CHANGE ORDER

Order No. 1

NAME OF PROJECT: Competitive Bid #WG23-17 – Outfit the Magnolia Recovery
Facility for the Baldwin County Commission, AL

BID NO. WG23-17 ADD 1

BID NO. WG23-17 - ADD-01 SHEET 1 OF 2

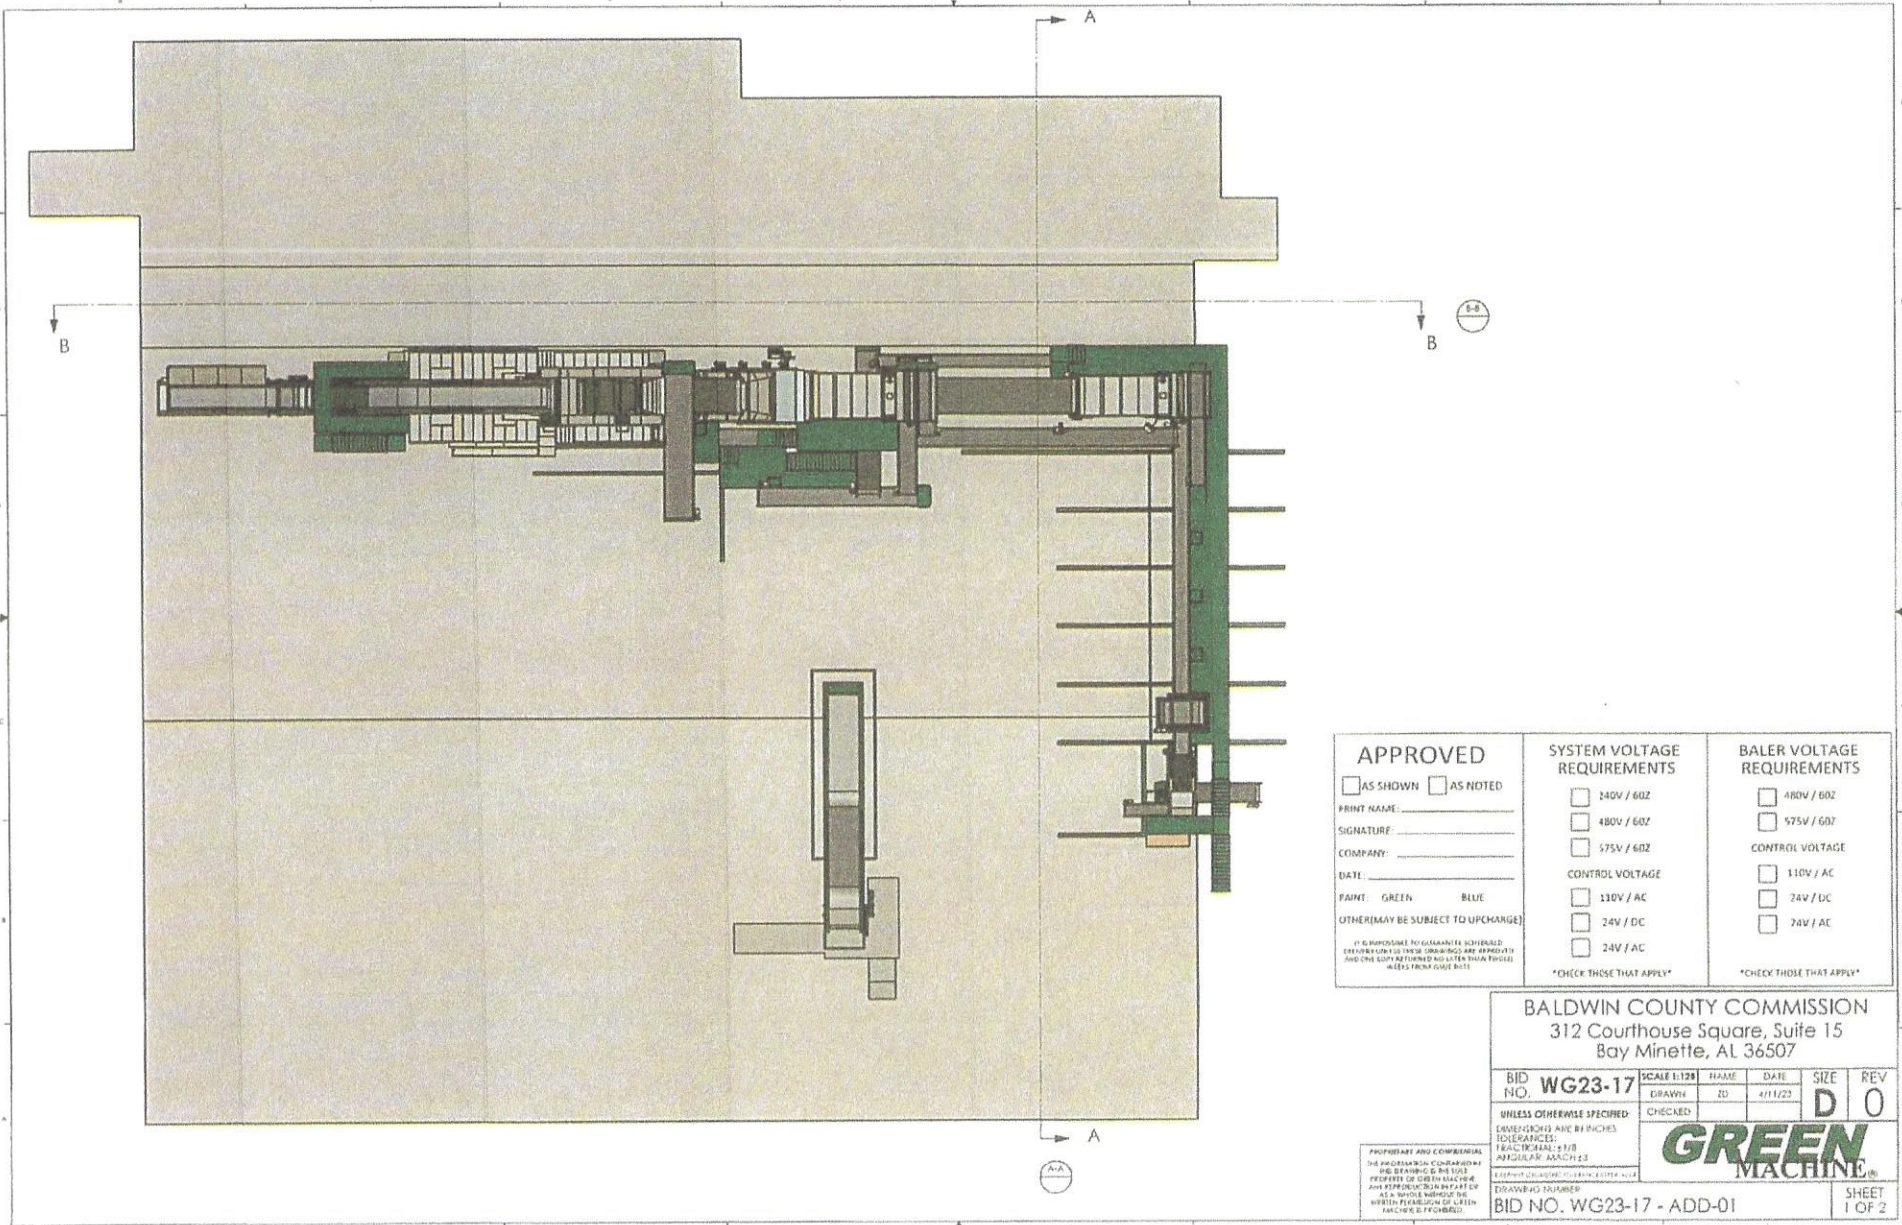
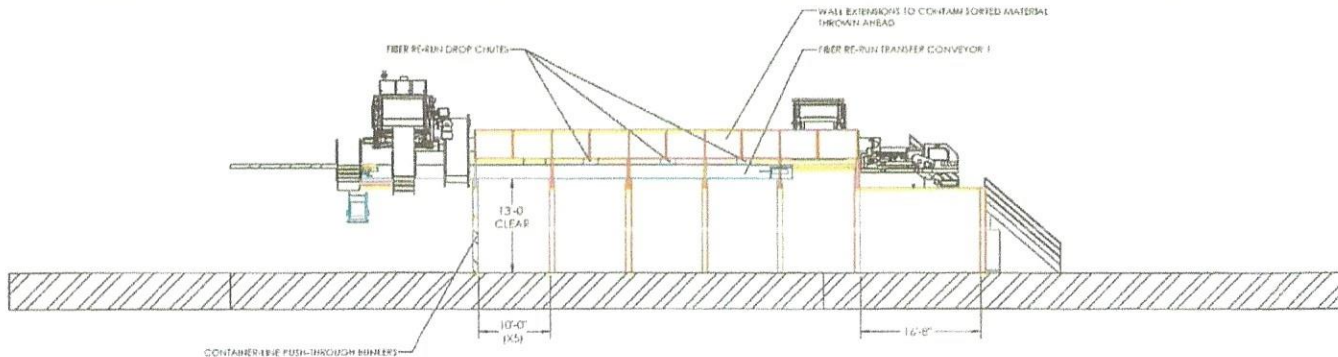
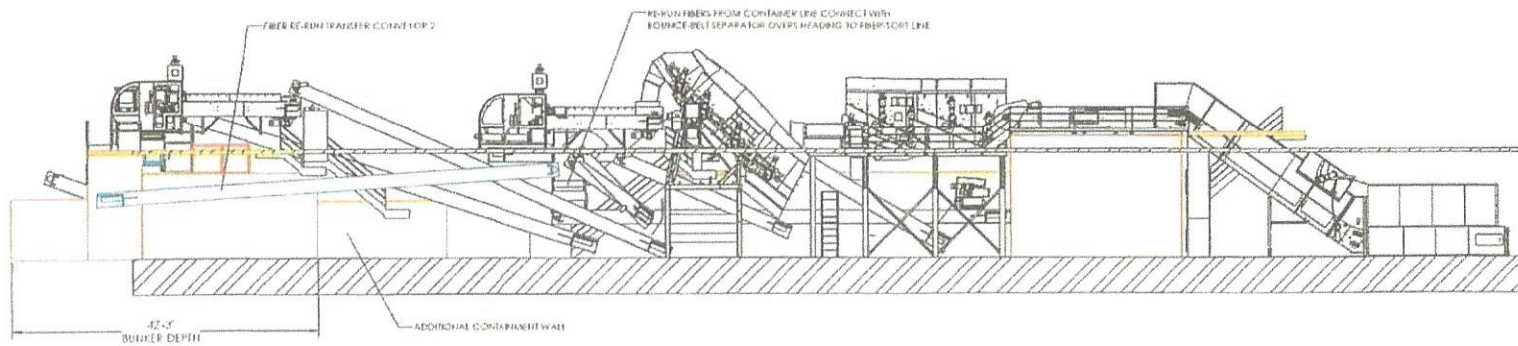
Green Machine is adding the bounce-belt separator system free-of-charge to the Baldwin County Commission which will increase fiber recovery before the container-sort line, as well as enhancing pick rates and cleanliness on the container processing line. Green Machine will also increase the loading zone lower horizontal of the C1 continuous system feed/pre-sort conveyor free-of-charge. The following options that will be priced out and offered to the Baldwin County Commission include a fiber re-run system and container push-through bunkers that will accommodate the Commission's loader clear height requirements.

OPTION A: CONTAINER-LINE FIBER RE-RUN SYSTEM

ONE: FIBER RE-RUN TRANSFER CONVEYOR 1 MODEL SL-24-58

- Belt Width 24"
Conveyor Length 58'
Belt Type 2 PLY 220# x 1/8" Rubber MOR COS
Motor 3 HP TEFC energy efficient (460/3/60), gear-reduced
Drive Direct
Drive Pulley 10" lagged head pulley
Tail Pulley 10" self-cleaning tail pulley
Drop Chutes (3)

ONE: FIBER RE-RUN TRANSFER CONVEYOR 2 MODEL SL-24-58

- Belt Width 24"
Conveyor Length 58'
Belt Type 2 PLY 220# x 1/8" Rubber MOR COS
Motor 3 HP TEFC energy efficient (460/3/60), gear-reduced
Drive Direct
Drive Pulley 10" lagged head pulley

OPTION B: CONTAINER-LINE PUSH-THROUGH BUNKERS

Corrugated steel bunker walls designed to support mezzanine and act as push-through bunker containment walls between stored materials. The taller bunkers will allow direct access to the observation deck from the container-sort deck and meet clearance requirements for the Baldwin County Commission's loader.

Bunker Size	13' 0" Tall x 42' 3" Deep x 10' 0" Clear (Wide)
Construction	3/16" Thick Corrugated Steel Bunker Walls 1/2" Thick Frames
Wall Extensions	Extensions on top of bunker walls to contain material when sorters throw ahead to prevent spillage out on floor; 3"x3"x1/4" angle iron with steel mesh constructed
